# Western Rail Coal Unloader

## ENVIRONMENTAL ASSESSMENT SUBMISSIONS REPORT

■ August 2007

Figure 2-1  
Viewshed from Coal Unloader

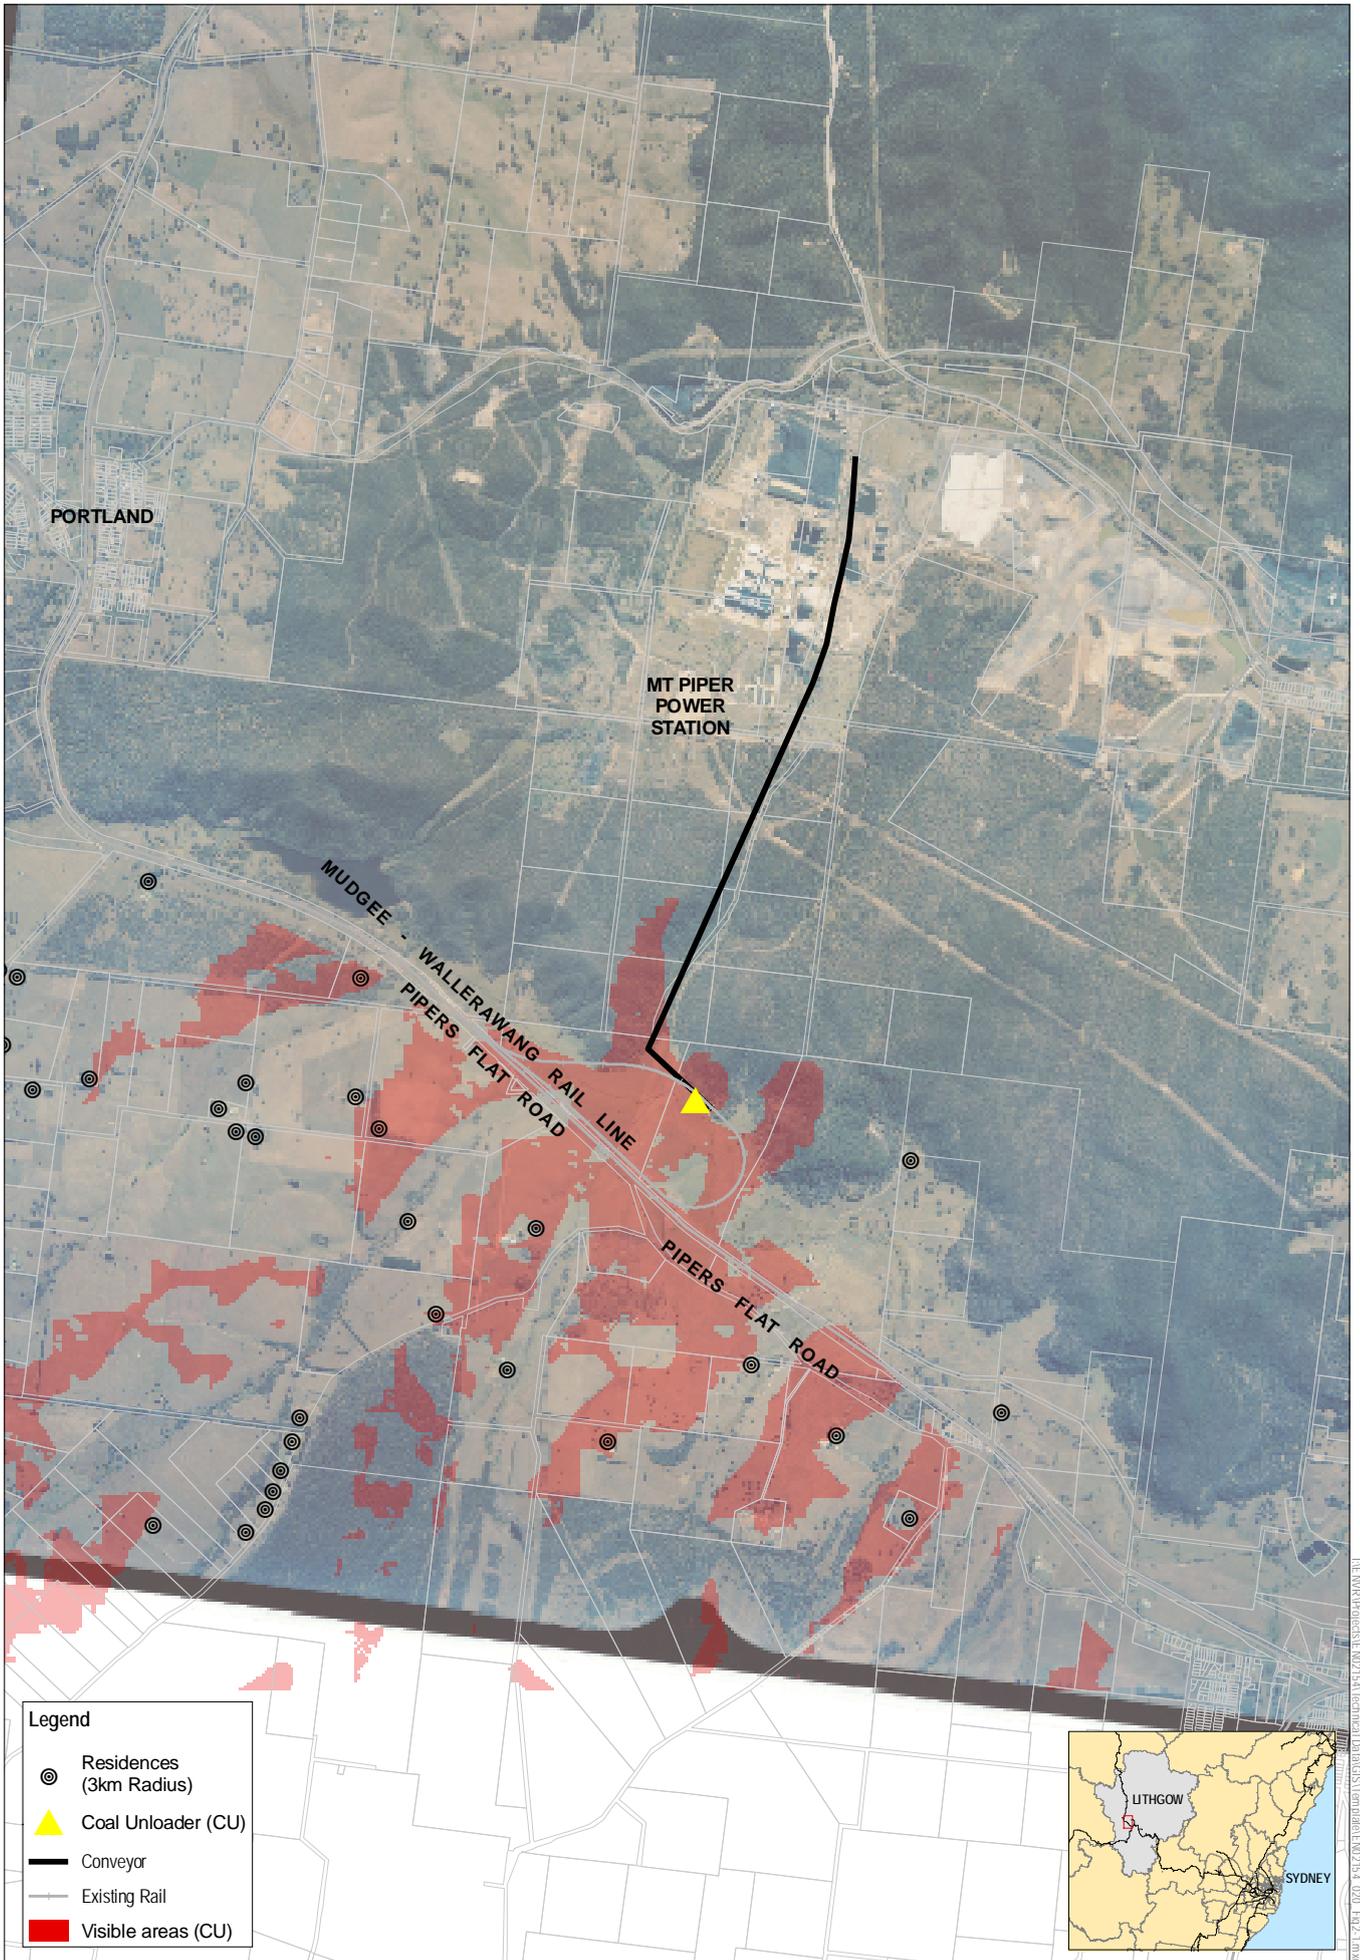
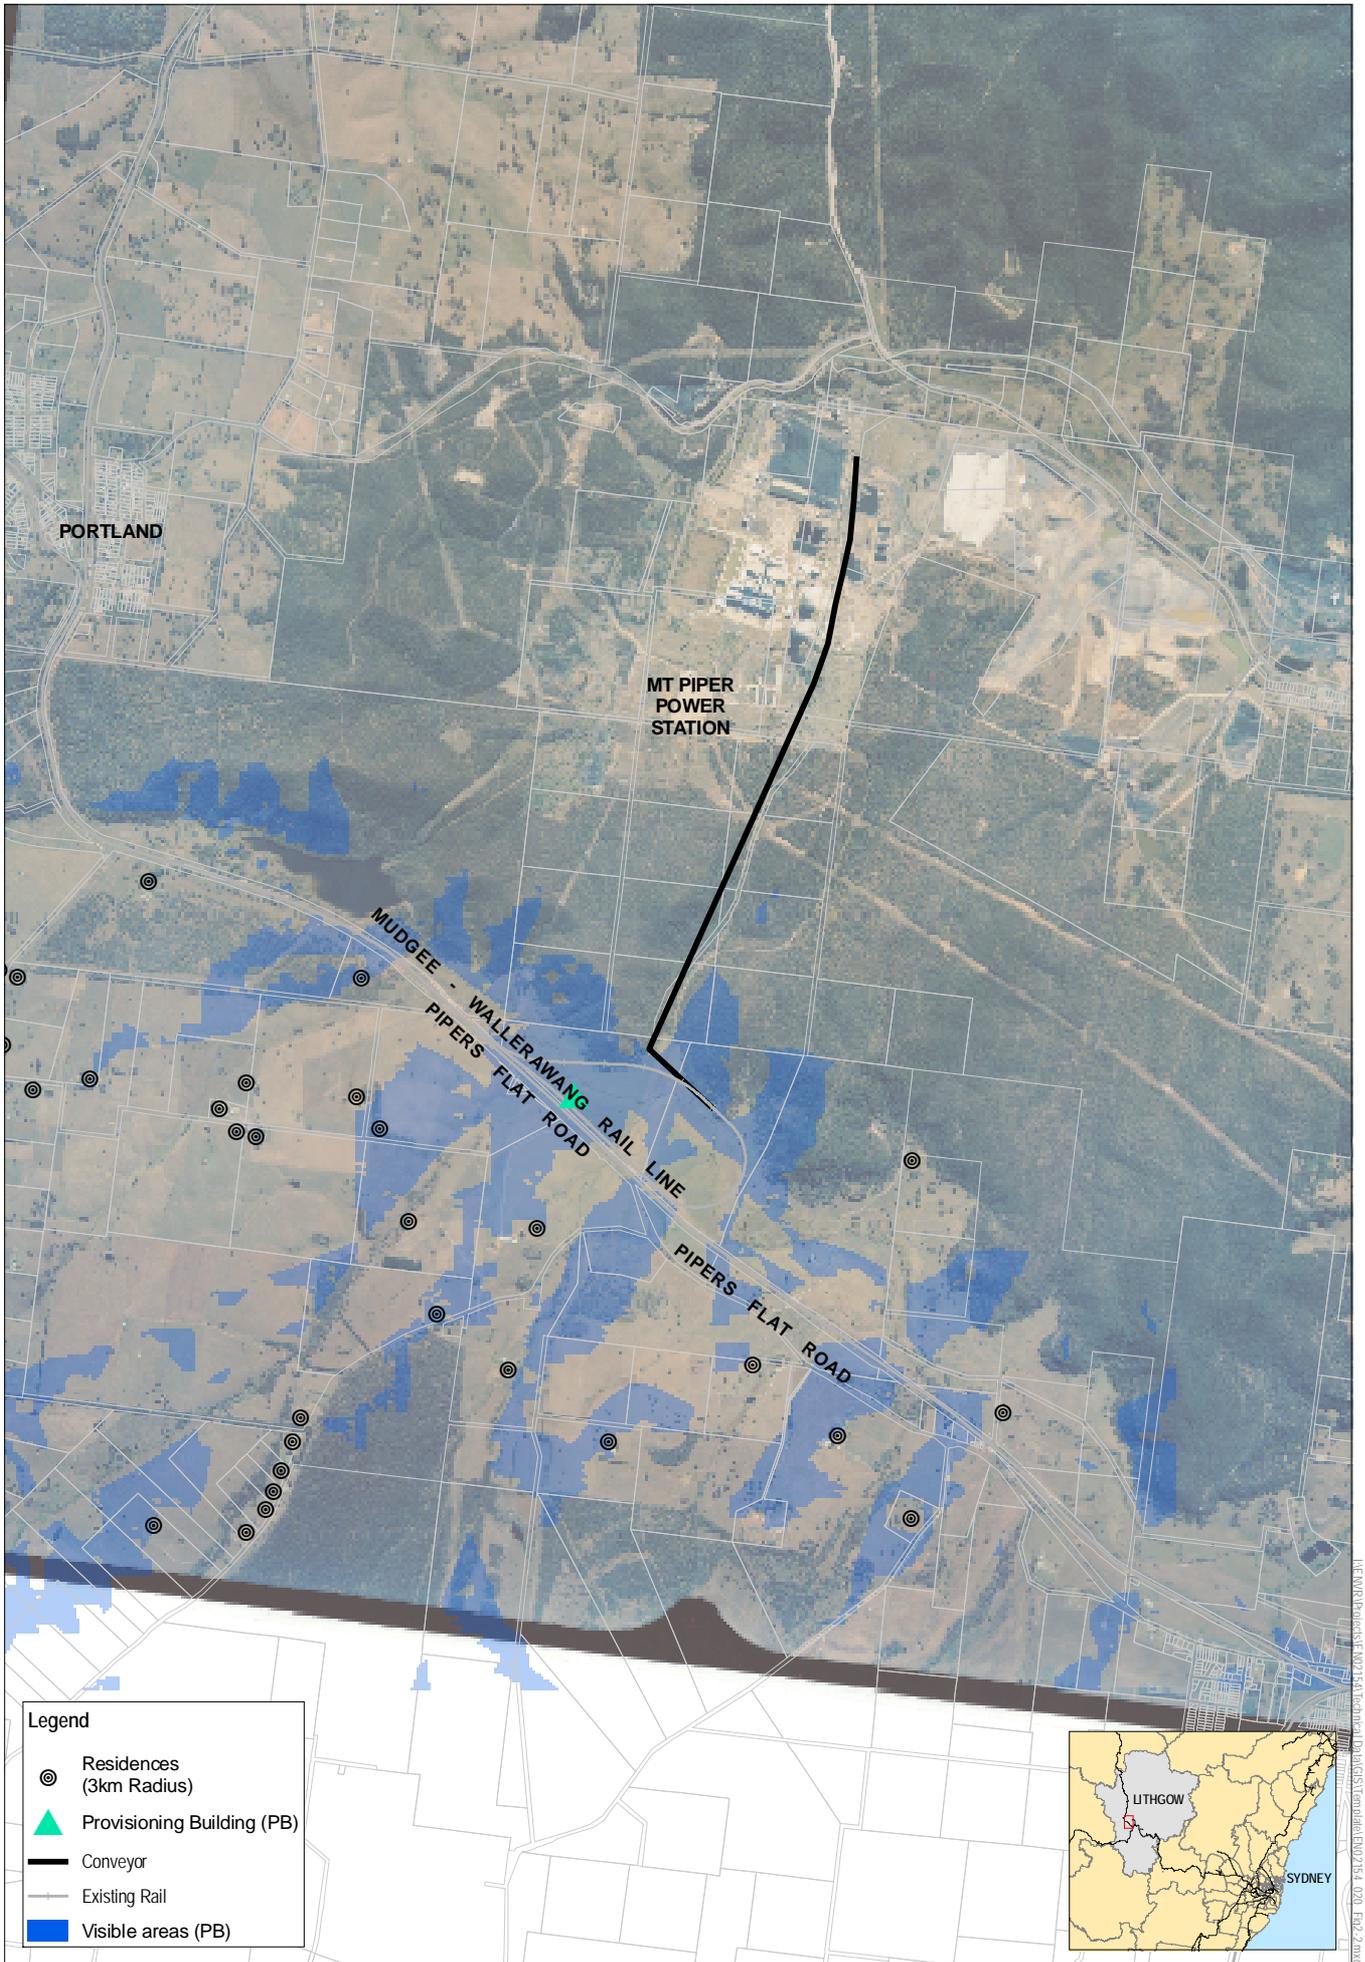
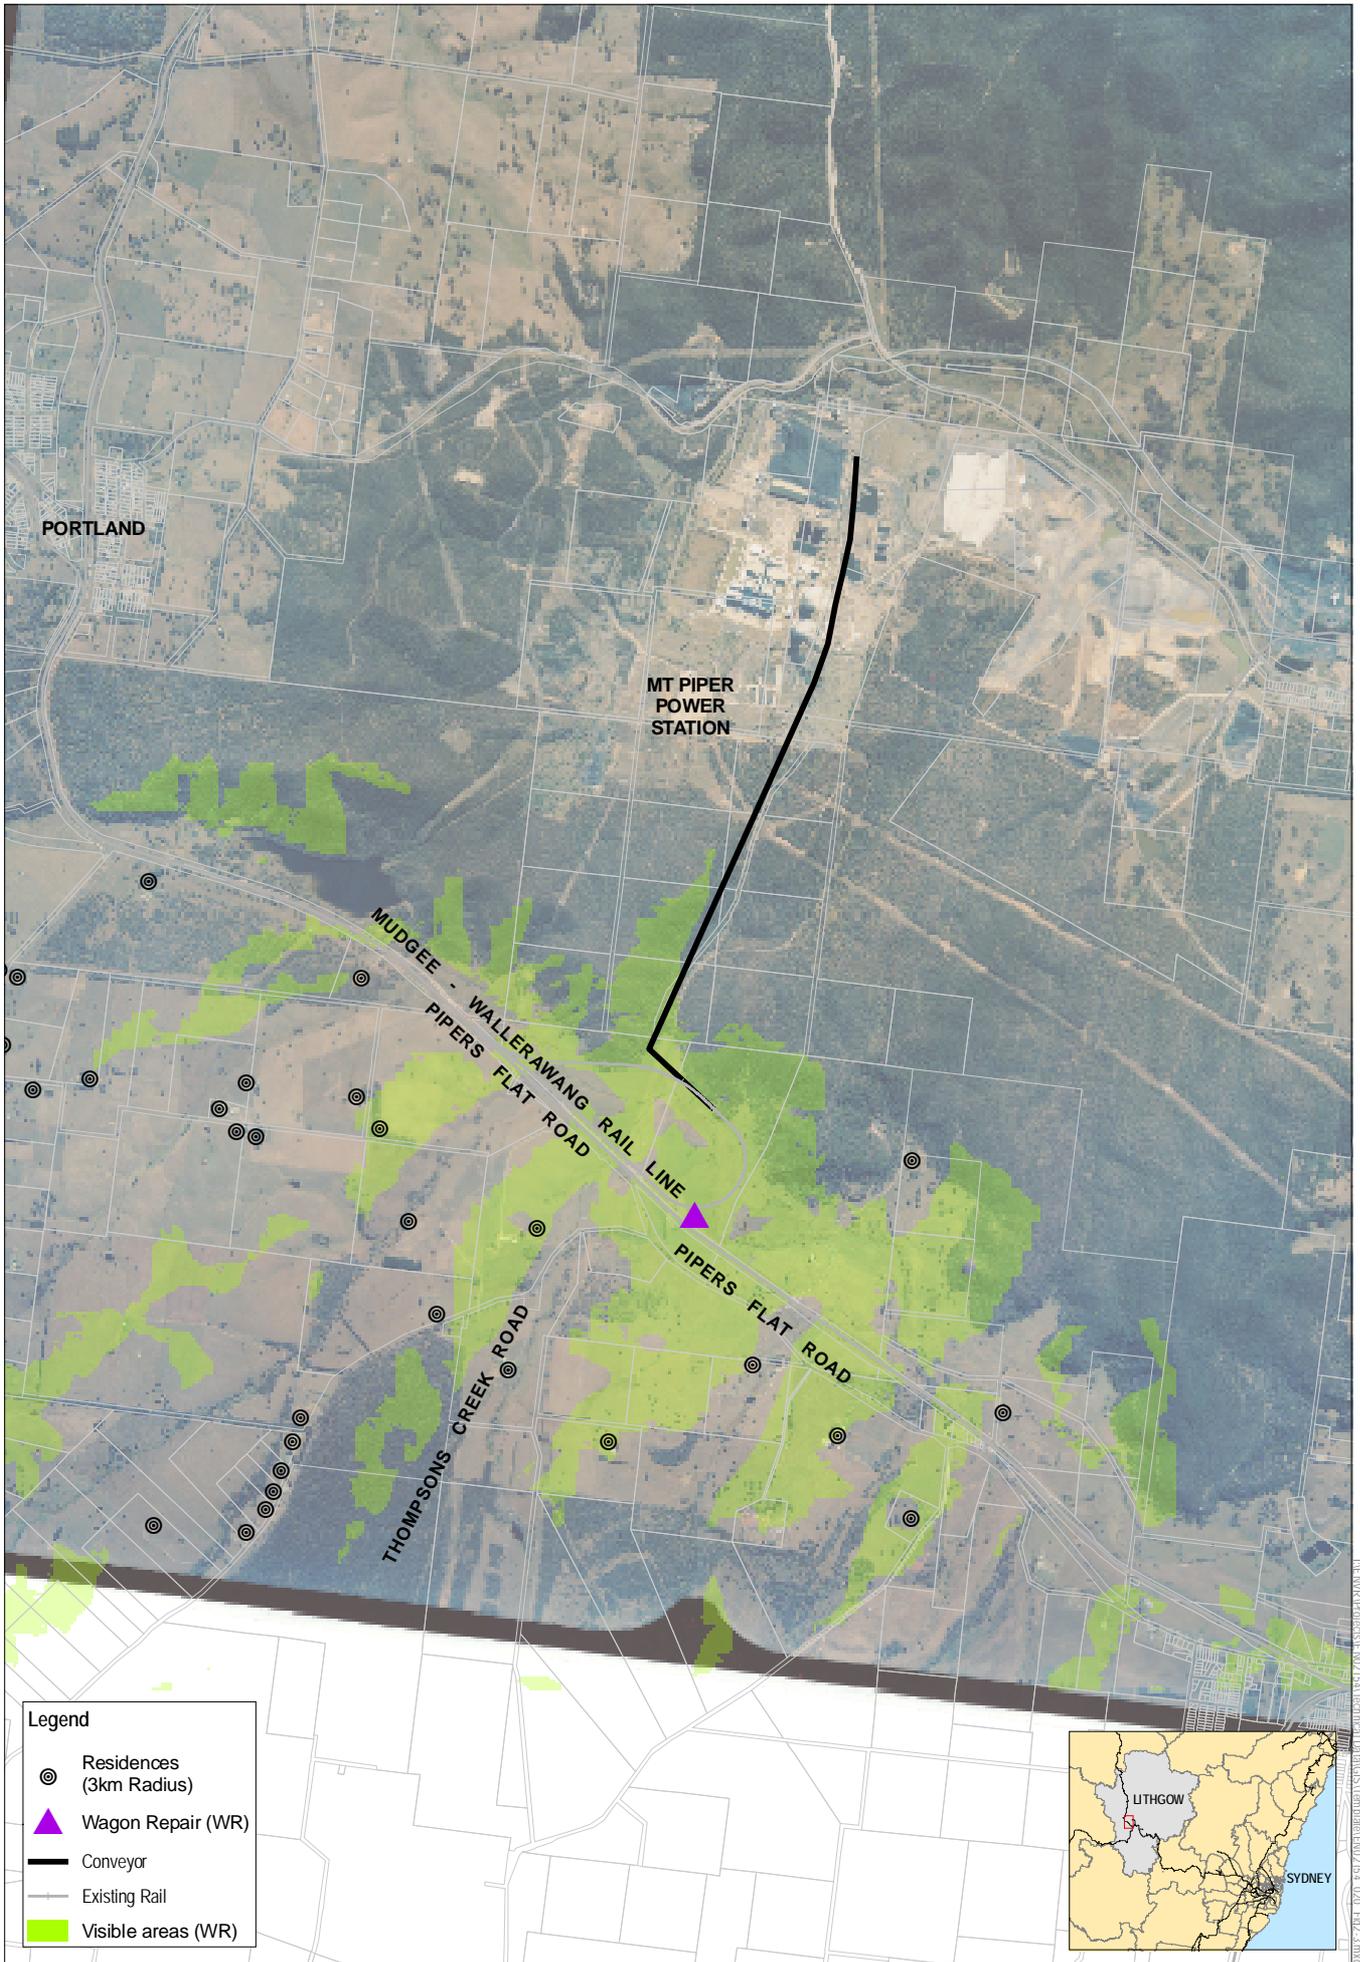
- Revision of Figure 5-10 such that it is expanded to a 3 kilometre radius from the view item (ie coal unloader structure) and it overlays residences in that area;
- A similar revision to the above but for the rail provisioning structure in isolation;
- A similar revision to the above but for the wagon maintenance area (including hardstand area with repair wagons) in isolation; and
- A figure consolidating the above figures (with residences overlaid).

Landscape planting is proposed for the rail embankments and for site buildings and screening vegetation along the southern site boundary would assist with screening views from Pipers Flat Road.

On the basis of implementing these mitigation measures, residual visual impacts would be regarded as low.
